## PRODUCT CHANGE NOTIFICATION

PCN Number: 432

Title of Change: Datasheet Update for LFB and LFC Series

LFB Series Old Product Dimensions:

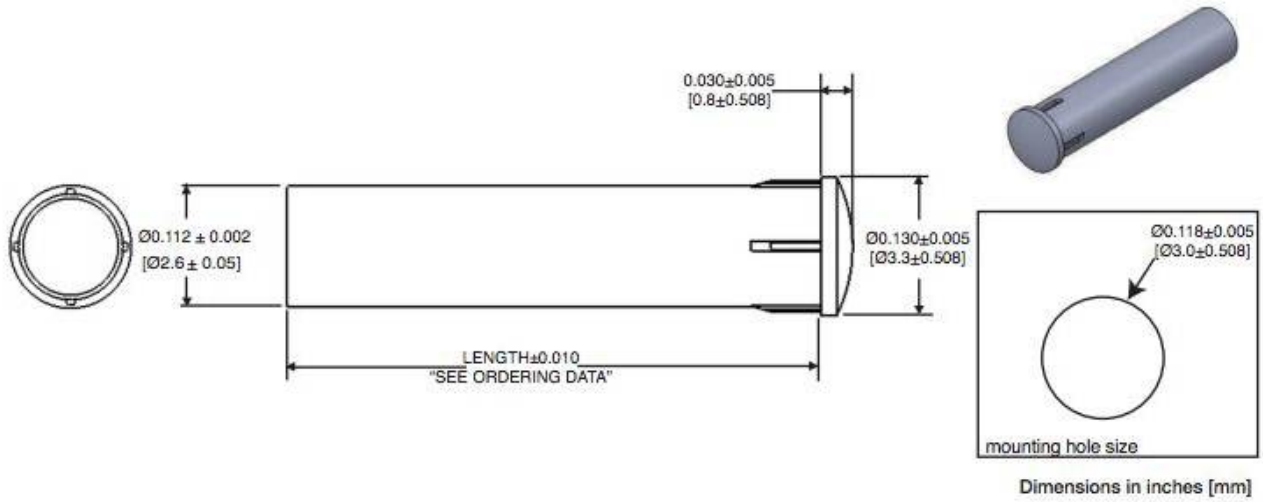
Reason of Change: The tolerances of the dimensions of the Series are updated. The updated datasheet is available on the website. Page 3 and 4 of this Product Change Notification show the changes.
